## **Access Compliance Report Public Rights-of-Way** (Curb Ramps)

Intersection ID: 29824 Main Street: MARVIN\_RD **Cross Street: WILKLEE DR** Location: ADA ID: 6F582A986321 Ramp Type: PerpDiag Initial Pass/Fail: Fail **Overall Compliance: No Severity Score:** 37.5

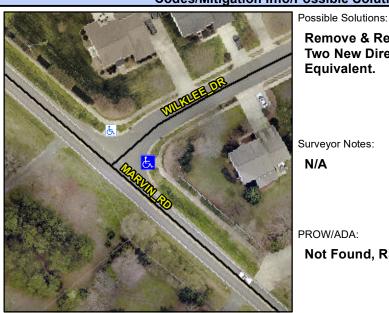
Not Found, R304.2.2, R304.5.3

Field Measurements/Component Compnance					
Compliance Description I		Data	Compliance Description		Data
N/A	Ramp Length (in)	111.0	No	Ramp Slope (%)	13.8
Yes	Ramp Width (in)	58.0	No	Ramp XSlope (%)	5.8
N/A	Flare Type LT	N/A	N/A	Flare Type RT	N/A
N/A	Flare Slope LT (%)	N/A	N/A	Flare Slope RT (%)	N/A
N/A	Flare Traversable LT?	N/A	N/A	Flare Traversable RT?	N/A
N/A	Landing Length (in)	N/A	N/A	DWS Provided?	N/A
N/A	Landing Width (in)	N/A	N/A	DWS Contrast?	N/A
N/A	Landing Slope (%)	N/A	N/A	DWS Length (in)	N/A
N/A	Landing X Slope (%)	N/A	N/A	DWS Full Width?	N/A
N/A	Landing Curb? (Y/N)	N/A	N/A	DWS Offset (in)	N/A
N/A	Shared Landing?	N/A			
N/A	Gutter Ponding?	N/A	N/A	Gutter Slope (%)	N/A
N/A	Gutter Lip Ht (in)	N/A	N/A	Gutter X Slope (%)	N/A
N/A	Painted X Walk1?	No	N/A	Painted X Walk2?	No
	X Walk 1 Direction	To NW		X Walk 2 Direction	To SW
N/A	X Walk 1 Width (in)	N/A	N/A	X Walk 2 Width (in)	N/A
	X Walk 1 Slope (%)	1.1		X Walk 2 Slope (%)	0.4

Remove & Replace Curb Ramp With Two New Directional Ramps or Equivalent.
